Event # 46289

POTENTIAL ISSUES WITH CERTAIN REGULATOR MODEL 77N-40 AIR REGULATORS

Subject: 10 CFR Part 21 report of potential issues with certain Regulator Model 77N-40

Figure 1

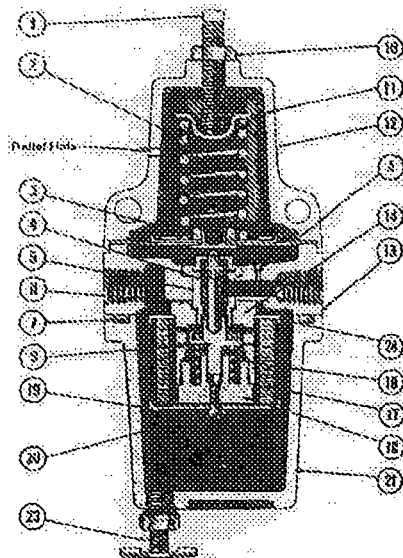
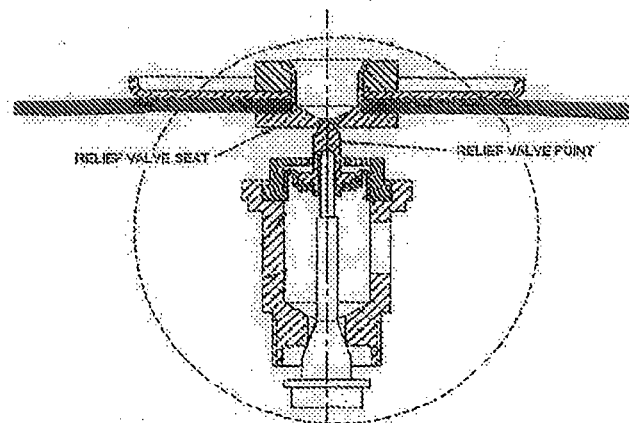
It was discovered during the evaluation process that the O-ring (#8 Figure 1) which isolates the pressure chambers can become damaged during the assembly process. A review of internal procedures found that the O-ring in question was assembled in the inverted position not visible to the technician during the process. Therefore the O-Ring had the potential to be damaged by the threads of the mating part.

It was also found that the supplier of the component referred to as the "Body" (#13 Figure 1) had not properly de-burred the bore that contained the sealing surface of the O-Ring on some components. The resulting sharp edge can be another source of potential damage to the O-ring.

- Inspection was added to the Body bore edge in our dedication plan.
- Inspection was added to the Relief Valve seat in our dedication plan.
- Procedures and instructions were updated to ensure that the O-Ring was assembled such that the technician can visibly see the components and ensure the O-Ring is not damaged during the assembly process.
- We reviewed the use of the "coining" technique and eliminated the practice from the current process. The technician is now instructed to assemble and test the Regulator without coining. If the Regulator does not pass the required testing the Regulator will be disassembled and the relief valve components replaced until an acceptable combination passes test.
- The existing inventory was reworked to the corrective actions above.
